Access Compliance Report Public Rights-of-Way (Curb Ramps)

Main Street: ETON_PL		Cross Street: O_NEILL_DR		Location:	SE
ADA ID: RPRK211027115626	Ramp Type: Type 6 - Directional 1	Initial Pass/Fail: Fail	Overall Compliance: No	Severity Score:	30
Codes/Mitigation Info/Possible Solution			Field Measurements/Component Compliance

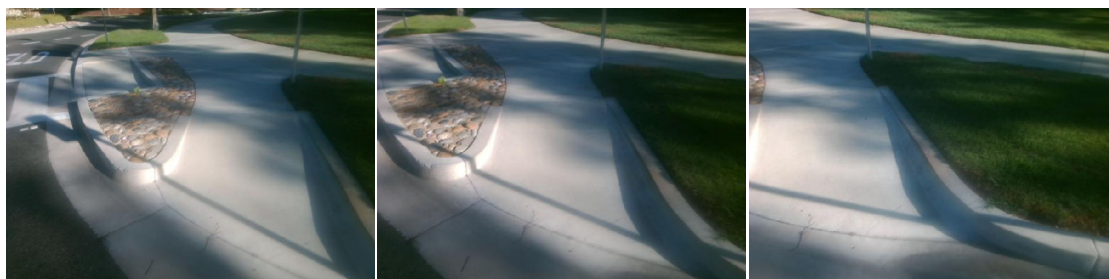
R204.3, R304.2.2, STD 1115

Remove & Replace Entire Ramp.
